**CITY OF SEATTLE
ANALYSIS AND DECISION OF THE DIRECTOR
OF THE DEPARTMENT OF PLANNING AND DEVELOPMENT**

Project Number: 3007906
Applicant: Larry Allen for 975 John Street, LLC
Address: 975 John Street

Land Use Application to allow a 7-story structure containing 145 residential units. Parking for 72 vehicles to be provided below grade. Existing 2-story building to be demolished.

Amenity space at Terry Avenue with storefront window system

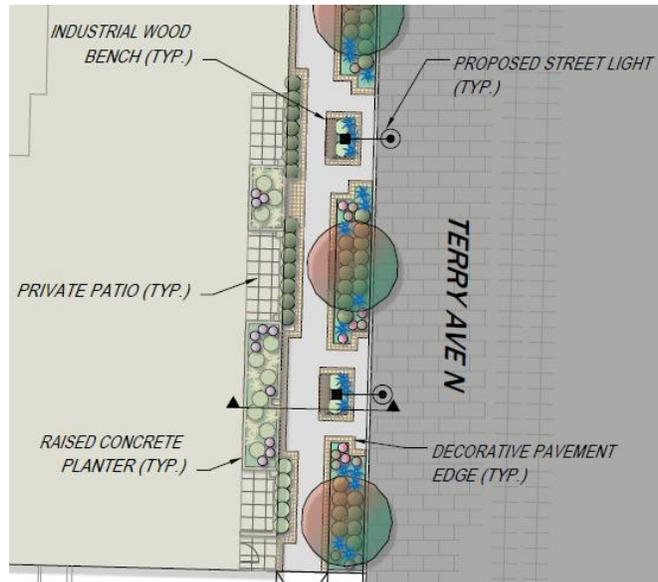
At the Final Recommendation Meeting, the Board responded that the amenity space works better at the courtyard than at the Terry Avenue street frontage. The Board expressed disappointment that the proposed design didn't include a street level use that may further activate the street front now or in the future (such as small live-work units with sufficient ceiling height for commercial uses). However, the Board agreed that the residential terraces have sufficient height and are close to sidewalk grade, and could serve to activate the street

At the Final Recommendation Meeting, the Board responded that the amenity space works better at the courtyard than at the Terry Avenue street frontage, as noted in response to Guideline A-4. The Board felt that the design as proposed meets this guideline, and didn't recommend any conditions.
